ATA Security feature Set Clarifications

To: T13 Technical Committee
From: Jim Hatfield
Seagate Technology
(with Jeff Wolford: Hewlett-Packard)
389 Disc Drive
Longmont, CO 80503
Phone: 720-684-2120
Fax: 720-684-2722
Email: James.C.Hatfield@seagate.com
Date: June 21, 2006

I propose that the following be incorporated into ATA/ATAPI-8 ACS as a full replacement for the referenced sections.

Figure 1 - Security State Diagram

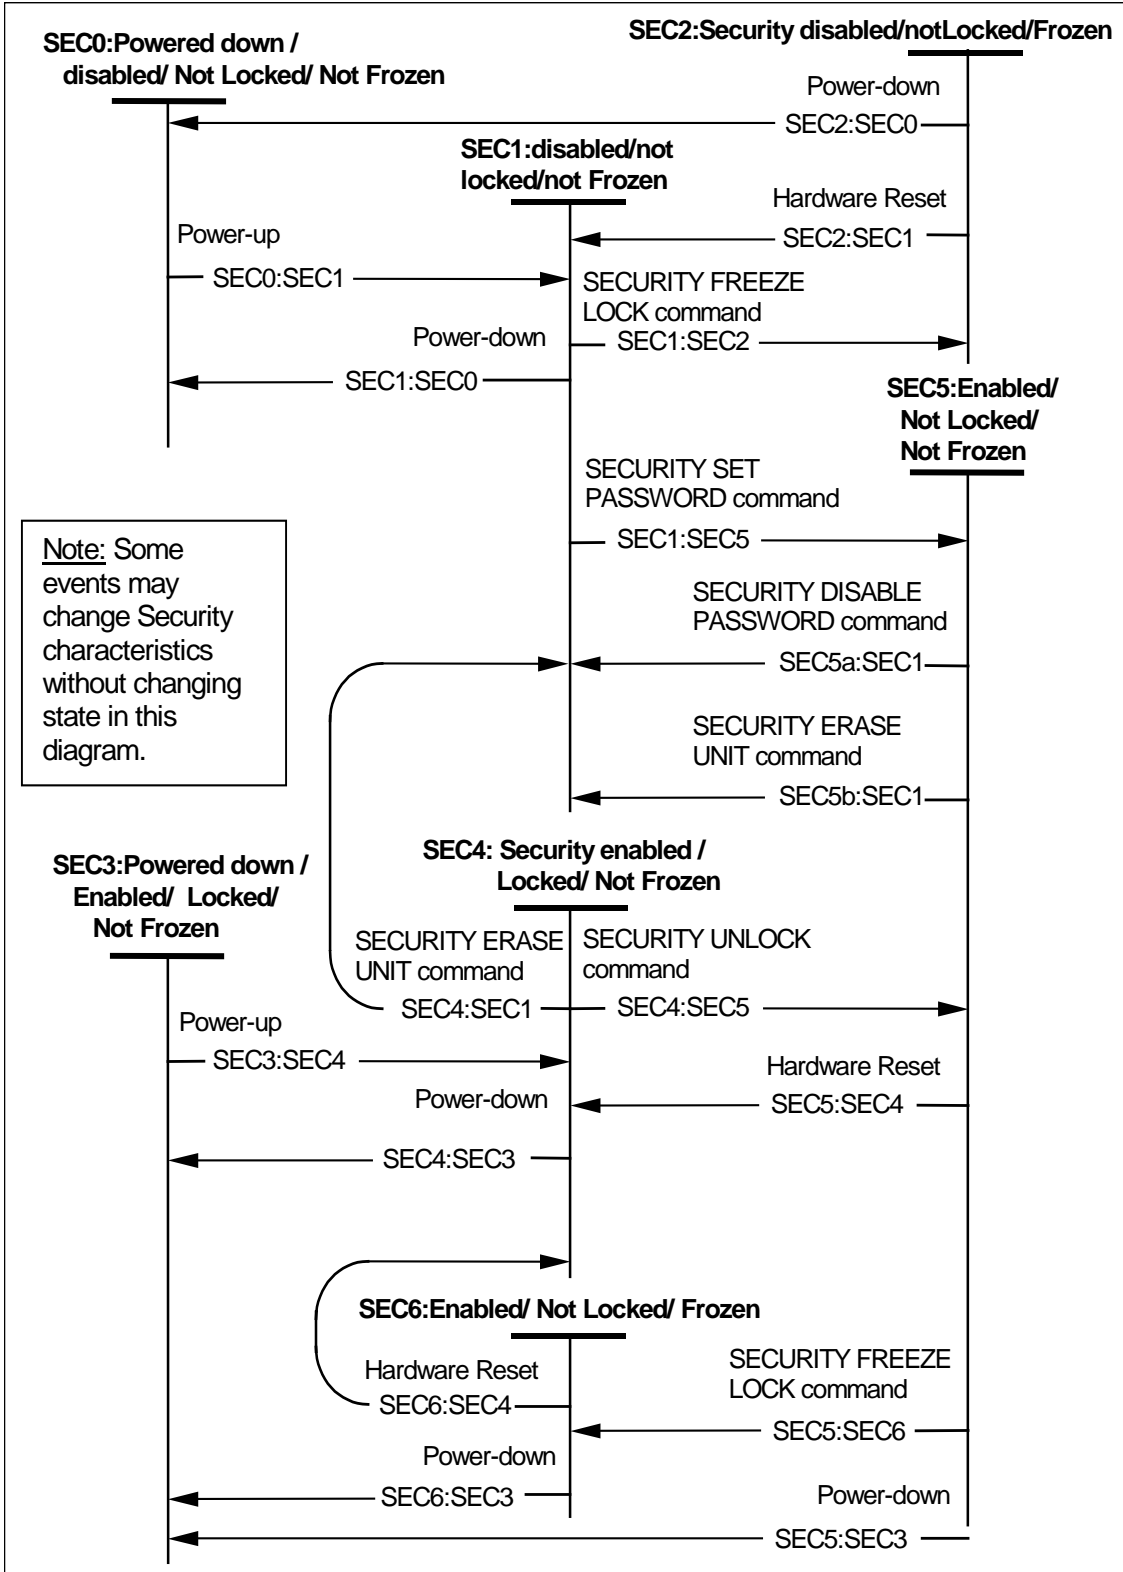
- 1) Shall hardware reset be removed as an exit from Frozen states ?
 - a. Resolution:
- 2) May SECURITY ERASE UNIT and SECURITY DISABLE PASSWORD be allowed to decrement the attempt counter for failed password comparisons ? If so, from which states may this be allowed ?
 - a. Resolution:
- 3) May SECURITY ERASE UNIT and SECURITY DISABLE PASSWORD be allowed to reset the attempt counter on entry to state SEC1 ?
 - a. Resolution:

[Editors note: change state names to include the full text ?]

[editors note: does the counter get re-initialized on a successful UNLOCK ? or does the counter retain its value ? Current text says only on poweron or hardware reset.]
